# product modification

M23275-1

Type DC503

## CHANNEL A TRIGGERING IMPROVED

Figure 1. Partial Front View of the TRIGGER CIRCUIT BOARD

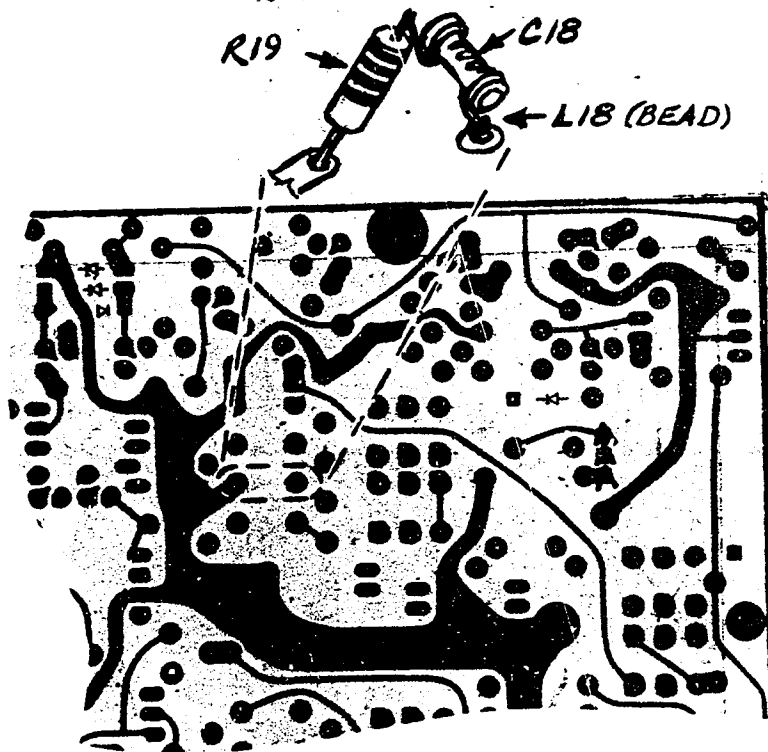
1. Remove the Electrical Side Shields.
2. Remove C10, 68pF, located parallel to R10, 47 $\Omega$ , from (INT SOURCE PULL) Switch, S10, to the Trigger Circuit Board. (Supersedes M20085)
3. Change the value of the following components on the Trigger Circuit Board:
  - a. C54 from 10pF to a variable capacitor, 5.5-65pF. (Supersedes a portion of M22527-1).
  - b. Q50, Q68 and Q95 from 151-0225-00 to 151-0427-00.
  - c. R38 and R40 from 2.00K to 510 $\Omega$ .
  - d. R60 from 1K 1/4W to 1K 1/2W.
  - e. R97 from 2K to 1.5K.
4. Add R19, 100 $\Omega$ , in series with C18, 170pF. Lift the ground side of C18 and tepee R19 between ground and lifted side of C18, insuring side shield clearance. NOTE: The manual schematic incorrectly shows the ferrite bead. L18, on the ground side of C18.

5. Make the following component value changes on the Main Circuit Board:
  - a. R542 from 22.1K to 4.42K.
  - b. R548 from 15.8K to 3.16K.
6. Replace the Electrical Side Shields with a new ventilated Electrical Side Shields (337-1399-04).

After installation of C54, the following procedure should be added to the INTERNAL ADJUSTMENTS PROCEDURE:

Apply 0.2V to 0.3V of fast rise ( $\leq 1$  nS) square wave at a frequency above 1 kHz to CH A INPUT. Attach a probe ( $\geq 5K$  paralleled by  $\leq 5$  pF input Z) to the junction of R97 and the emitter of Q95. This probe must work into an oscilloscope (sampling or real time) where response with the probe has a rise time  $\leq 2$  nS. After obtaining the optimum signal by adjusting the LEVEL control (R45), adjust the oscilloscope for about 5 divisions of vertical display and 10 nS/division horizontal display. Adjust C54 for optimum front corner with less than 20% aberration peak to peak.
